SERVICE BULLETIN XK-SB004 Rev NC Page 1 of 4

SUBJECT: *ALTERNATOR OUTPUT STUD HARDWARE INSPECTION*

MODELS AFFECTED: CCX-2300-0070 through CCX-2300-0110, CCX-2300-0112, CCX-2300-0113

PURPOSE: *Cub Crafters has been made aware of an instance where incorrect hardware was found installed on "B" terminal of the alternator after experiencing COM noise and charging issues.*

Figure 1: Under Engine, Looking up

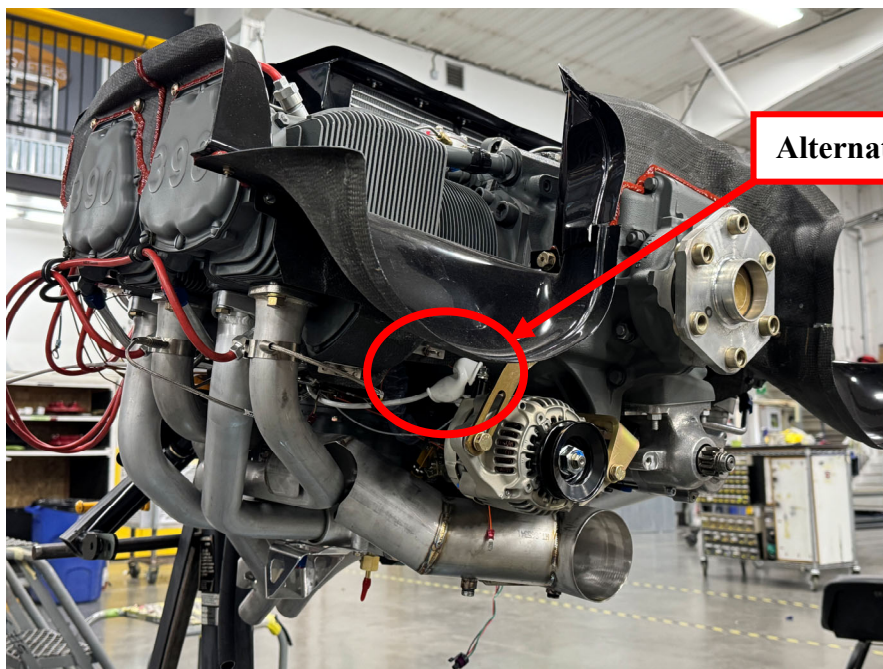
1. Read all instructions before beginning any work.
2. Remove cowling, retaining all fasteners.
3. Locate the "B" terminal of the alternator (see Figure 1).
